## WATER LICENCE INSPECTION FORM

Licensee				Licensee Representat	ive				
Hamlet of Whale Cove				Paul Kaludjak, Megan Lusty (CGS)					
Licence No. / Expiry (DD/MM	/YYYY)	YY) Representative's Title							
3BM-WHA0914 (	31/05/20	014)	•						
Date of Inspection (DD/MM/	YYYY)			Inspector					
07/07/2014				WRO C. Wilson, A/WRO J. Hack					
Activities Inspected Camp Roads/Hauling	Drilling Other:		Mining		nstruction her: <b>MUNI</b>	CIPAL UND		្ធ Fuel Storaរូ	ge
Conditions: A - Ac	ceptable	С	- Concern	U - Unaccept	table	NA –	Not Applicable N	I – Not In	spected
Water Use	Condition	Comment	<b>Site Condit</b>	ions	Condition	Comment	Haz/Mat Management	Condition	Comment
Source: Fish Lake	Α	2	Water Mana	gement Structures	U	5,6	Storage	U	12
Intake/Screen	NI		Culverts / B	ridges	NA		Spills	U	13
Flow Measure. Device	U	2,4	Drainage		U	5			
Water Use: <b>Unknown</b>	U	3	Erosion / Se	ediment	NI				
Recirculation ( y /n)	NA		Signage		U	14	Administrative

PHOTO 6
 N 62° 10′ 9.82″, W92° 35 47.23

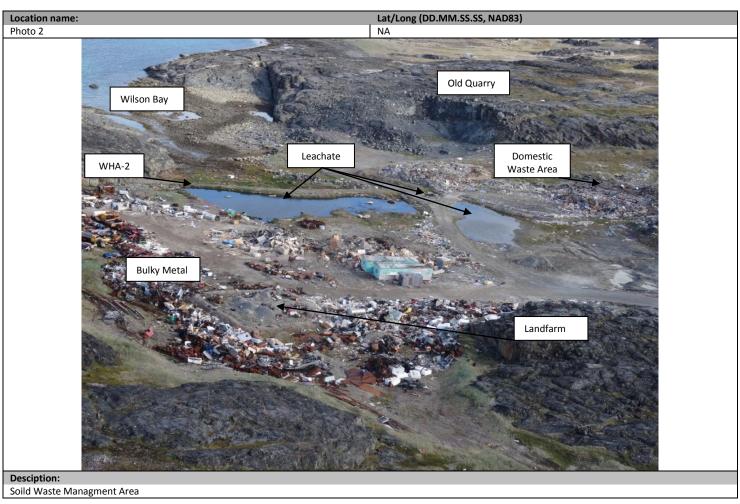
- 10) The inspector is concerned with the overall construction of the Landfarm Facility; the as-built drawings, as required under PART E item 4, are not available for review on the NWB FTP website. The facility is surrounded with bulky metal and the berm wall structural integrity are of concern (photo 6).
- 11) The monitoring stations are lacking the appropriate signage as required under PART B item 5.

Land farm (Left to right)-exposed liner and what appears to be slumping and erosion to the exterior of the berm walls; exposed liner and material removed from the exterior of the berm walls.
